STAFF REPORT

SUBJECT: H-2021-0054

Victory Commons Final Plat No 2

LOCATION: The site is located at 130 E. Victory Rd.

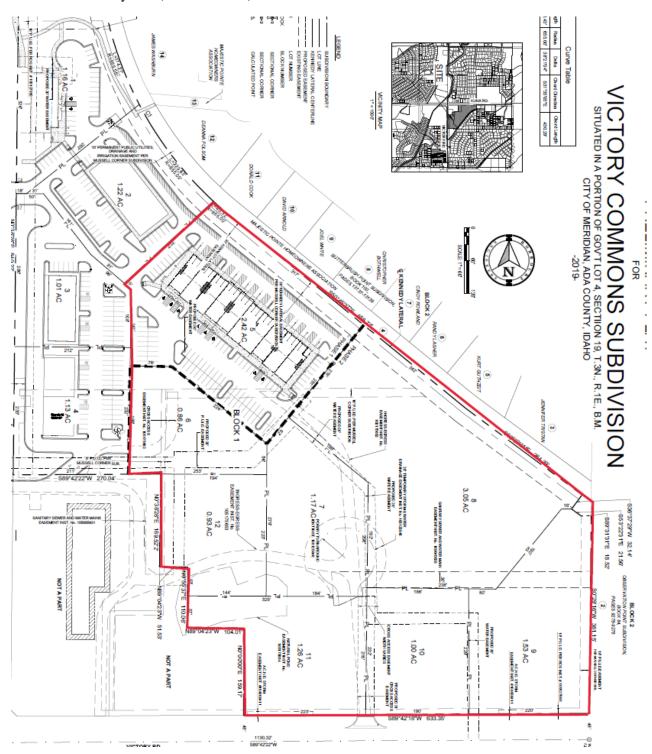
A condition of approval of the preliminary plat was that prior to signature on the final plat for this phase, the applicant shall grant cross access to parcels #R5915720030, R5915720042 and R6242270030 (parcels to the south and east of the property). The applicant submitted recorded access easements to all three of these properties, but only the access easement to Parcel R6242270030 (500 E. Victory Rd) is shown on the plat. The plat should be revised to show access easements to the other two properties.

- 2. Direct lot access is prohibited to S. Meridian Road and E. Victory Road.
- 3. Prior to signature on the plat, the applicant shall show on the plat recorded cross agreements or add a plat note that grants cross access to parcels #R5915720030 and R5915720042 in accord with the amended development agreement.

VICTORY COMMONS SUBDIVISION NO .2

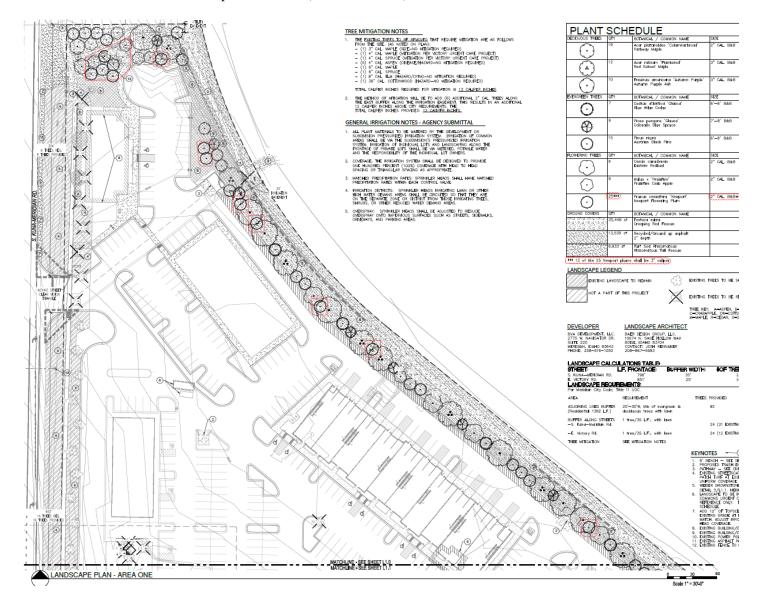
- a. Notes #15, 20, 2, 23 and 24 insert instrument numbers.
 - b. Landscape buffer along E. Victory Rd shall be on a common lot or on a permanent dedicated buffer, maintained by the property owner or business owners' association per UDC 11-3B-7.
